Comprehensive Review of Test Area North CERCLA Cleanup Plan at the

Idaho National Laboratory

Amended

Revision B

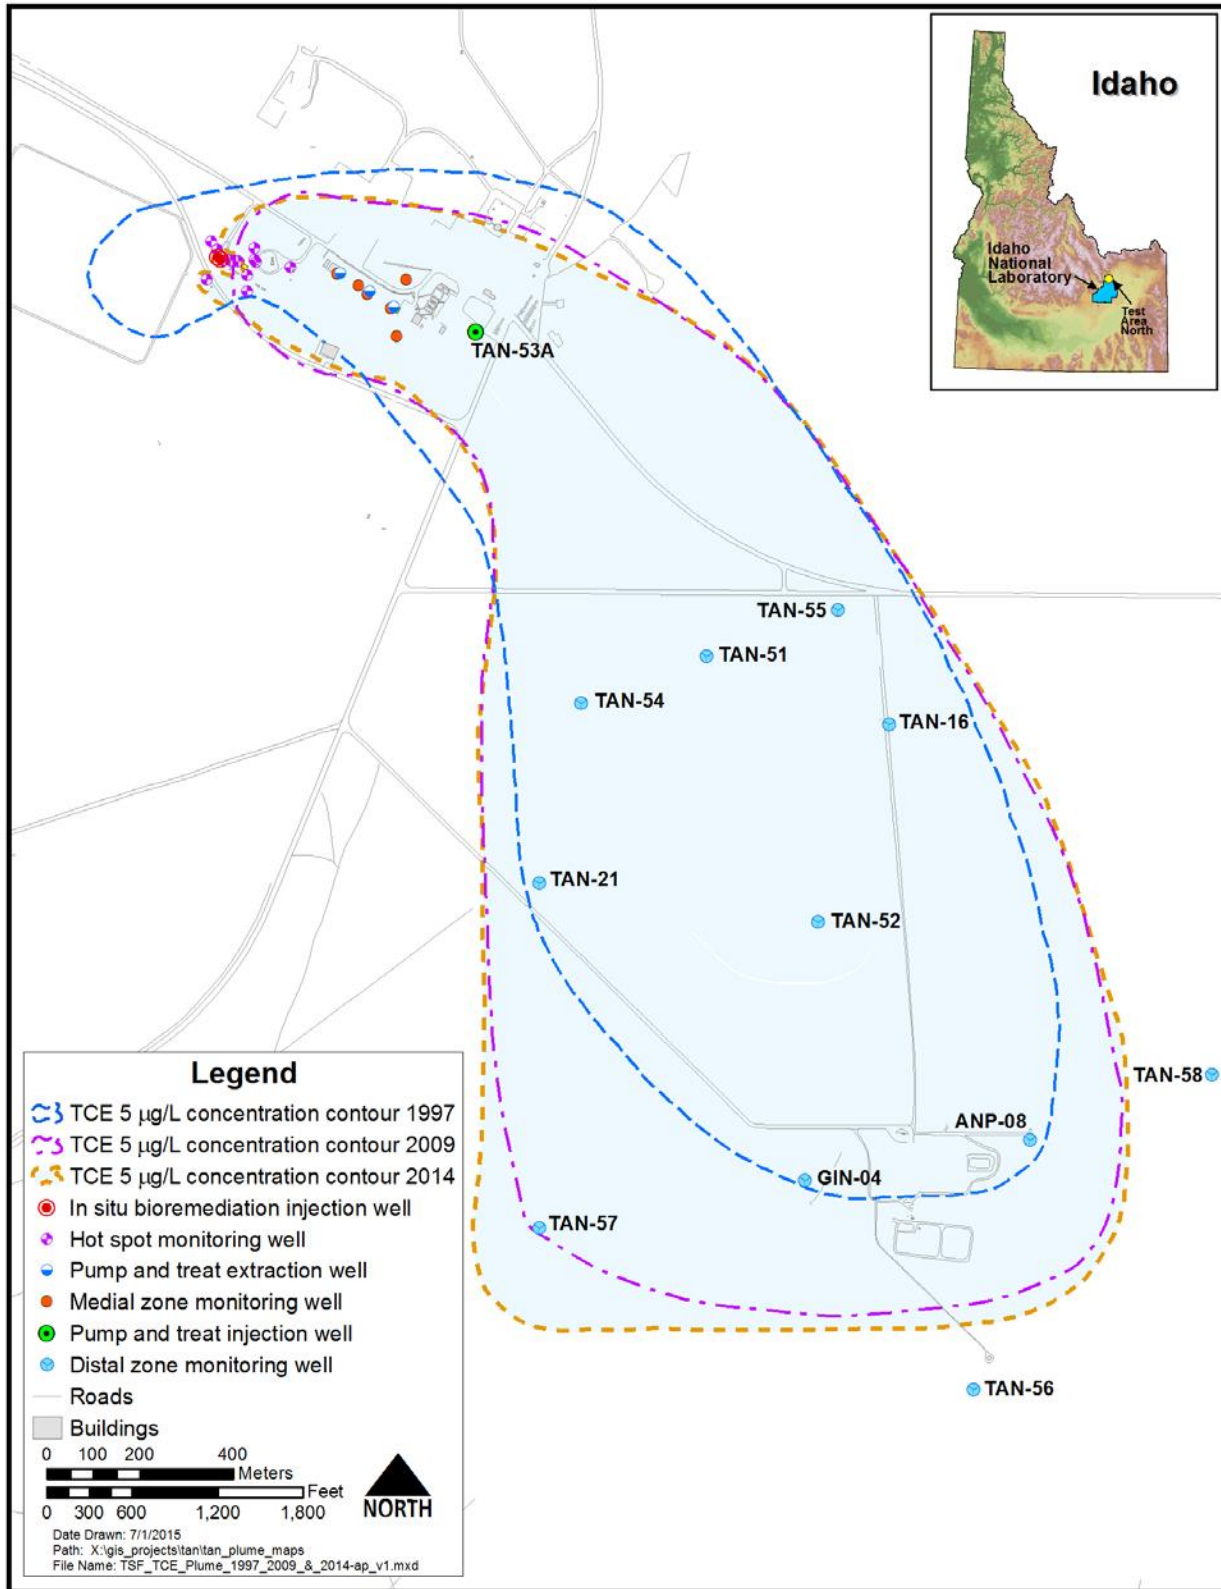
The below figure graphically shows the expansion of TCE from 1997 to 2014 in the Test Area North (TAN) groundwater contaminate plume. ¹⁵ An estimated 35,000 gal. (132,489 L) of TCE and a total of 53.53 Curies of radioactivity have been disposed in the TSF-05 well. ¹⁶

Figure 2-17. Cesium-137 concentrations in radionuclide monitoring wells (2000 to 2014).

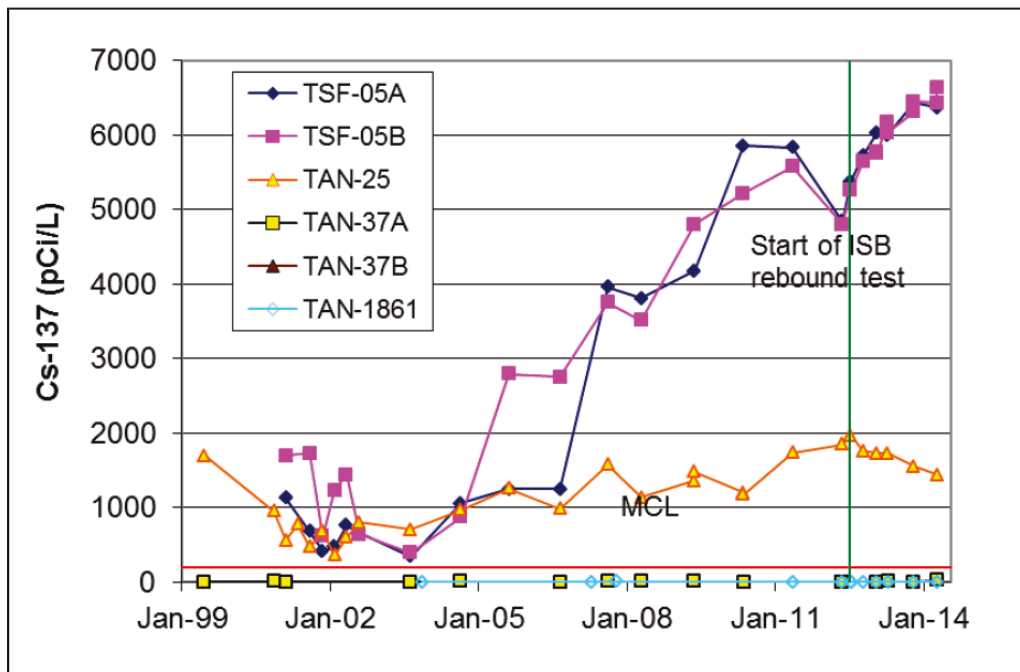
“Cesium-137 occurs in wells TAN-25, TAN-37A, TAN-37B, TAN-1861, and TSF-05B in concentrations above the proposed MCL in the Record of Decision of 119 pCi/L and the current derived MCL of 200 pCi/L in TSF wells, and have **gradually increased** since the start of ISB rebound test.” [DOE/ID-11513, pg. 2-25]

Figure 2-20. Strontium-90 concentrations in monitoring wells located near source and downgradient from the residual source (2000 to present).

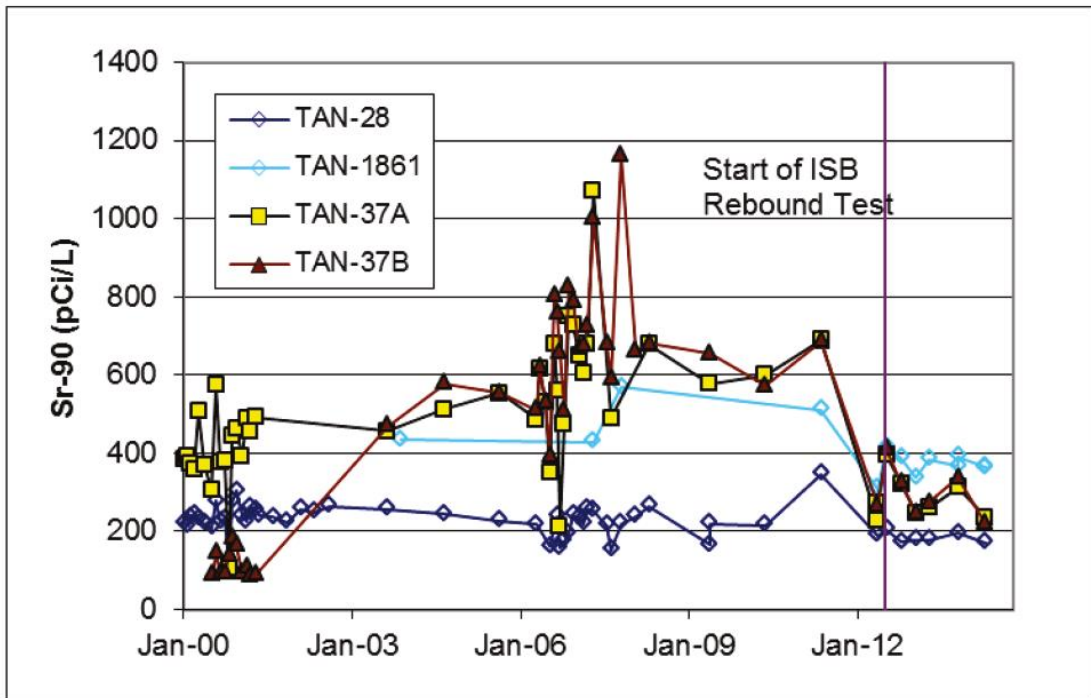
TAN Groundwater Strontium-90 (Sr-90) Monitoring¹⁹
 EPS's Maximum Concentration Limit is 8 pCi/L
